From: Guoda Vaitkeviciute <guoda.vaitkeviciute@lanproservices.co.uk>
Sent: 25 July 2025 16:39:25 UTC+01:00
To: "Emy Circuit" <Emy.Circuit@wokingham.gov.uk>; "Sophie Morris" <Sophie.Morris@wokingham.gov.uk>
Cc: "Tom Pike" <tom@lanproservices.co.uk>; "Jean Mulovi" <Jean.Mulovi@wokingham.gov.uk>; "Kane White" <Kane.White@wokingham.gov.uk>; "Connor Corrigan" <Connor.Corrigan@wokingham.gov.uk>
Subject: SWDR - Conditions 12, 13 and 15 (Application Reference: 250213) and 5 and 6 (Application Reference: 242838)
Attachments: WMHP-TG-SRWG1-SK-DD-0594-P01 - DITCH PROFILES.pdf, 4977_Response to Consultee Comments 5 and 6_v1.2_20.06.2025.pdf, 4977_LAN_XX_XX_RP_L_1000 Written Landscape Specification P04 - Tracked.pdf, 4977_LAN_XX_XX_RP_L_1000 Written Landscape Specification P04.pdf, 4977_LAN_XX_XX_RP_L_1001_Landscape Management Plan P05 - Tracked.pdf, 4977_LAN_XX_XX_RP_L_1001_Landscape Management Plan P05.pdf, 4977_SWDR_Biodiversity Net Gain Report (tracked changes)_BW_V4-0.pdf, 4977_SWDR_Biodiversity Net Gain Report_BW_V4-0.pdf, 2025_07_22 EA response conds 5_6.pdf, Environment Agency response 2025_07_04 conditions 12, 13 & 15 250213.pdf

Please find attached the Applicant's responses to the co

Image 2: August 2023, showing established wildflowers and headwall guardrails hidden:

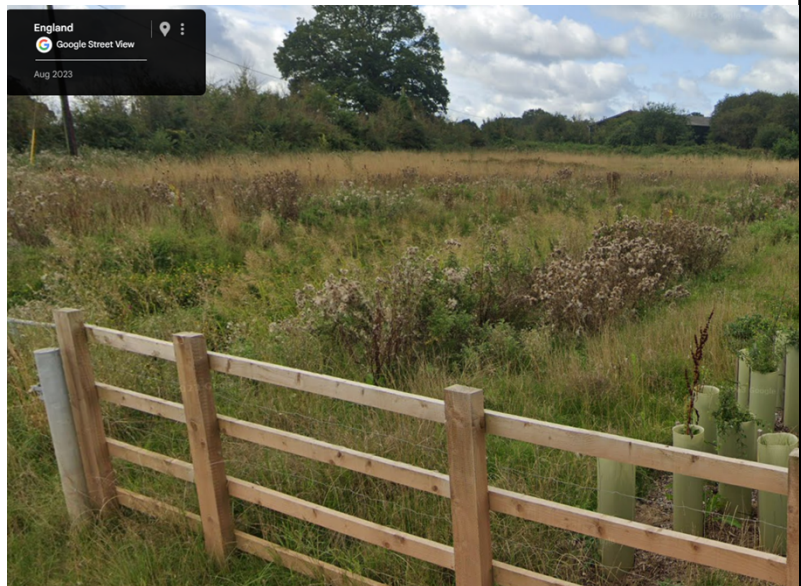
2.5	Although in 6.3.112 and 6.3.113, the height and width of the berms and the slope, and monitoring at different times of year, is mentioned, there is no mention of expected water levels at each time of year. Nor is there any mention of cross sections for these berms. Additionally, the berms are very uniform all the way along. There should be variation in berm height and slope along the length of the channel.	Refer to drawing WMHP-TG-SRWG1-SK-DD-0594 submitted under Discharge of Condition 5 (Application Reference: 242838). This drawing is attached with this response for reference. The water level within the diverted Luckley Brook channel is expected to vary seasonally, ranging from dry conditions to full submergence of the channel. While we understand the ecological benefits of introducing variation in bench levels, this is not being considered as part of the current design. The principal of the channel remains on maintaining consistent conveyance and hydraulic performance within the channel, in consistency with the full planning application (reference: 192928). It is also understood this variation will generate naturally over time through the deposition of sediment. A similar arrangement has been approved and implemented at Eastern Gateway, Waterloo Road, Wokingham (upstream of the Emm Brook), which shows fast establishment of wildflowers that contribute to creation of variation in the ditch profile from the engineered design:
